CITY OF ALBUQUERQUE

**RE: Amaran Senior Living
9100 Holly Ave NE
Grading and Drainage Plan
Engineer's Stamp Date: 2/15/19
Hydrology File: C20D079**

Based on the submittal received on 4/1/19, this project is cannot be approved for Building Permit until the following are corrected:

CG101

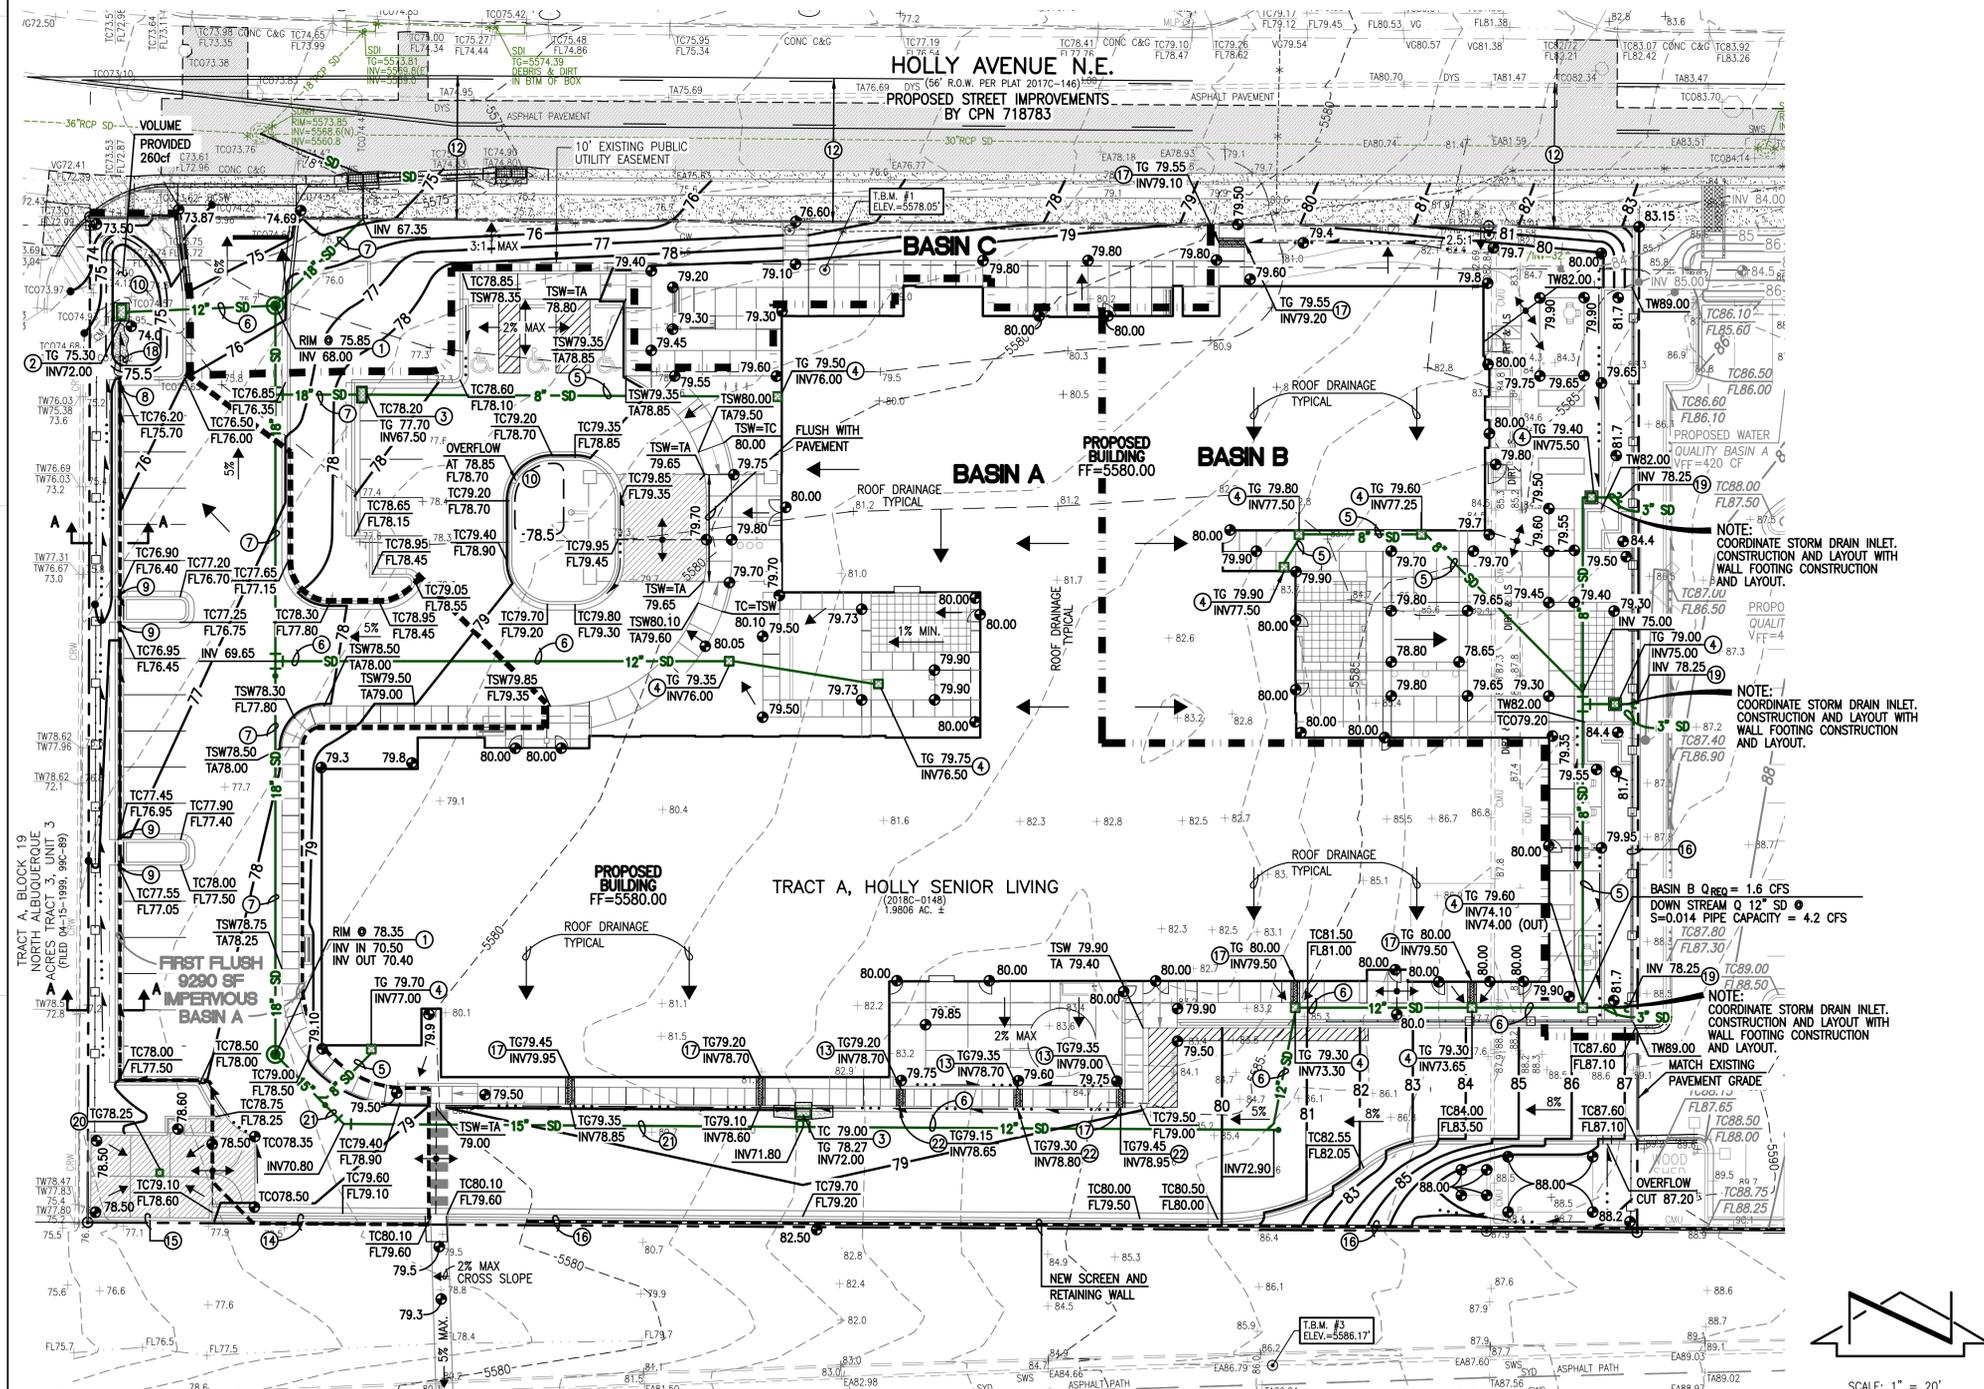
1. Hydraulic Calculations are required per DPM 22.3:
 - a. HGL calculations for the pipe network, determined along the energy grade line, are missing.
 - b. Pond routing and water surface elevations for both the first flush and the 100-year volumes are missing.
 - c. Grate capacity for the pond outlet needs to be checked using 3.72SF clear space (1.86SF w/ 50% clogging). The new grate Standard Detail is attached.
 - d. Provide a section through the pond and property line, showing that the downhill property will not be adversely affected by the placement of the pond.
2. Payment in Lieu (Amount = $2180\text{CF} \times \$8/\text{CF} = \$17,440$, per Sheet C100) of management onsite for the required storm water quality volume must be made
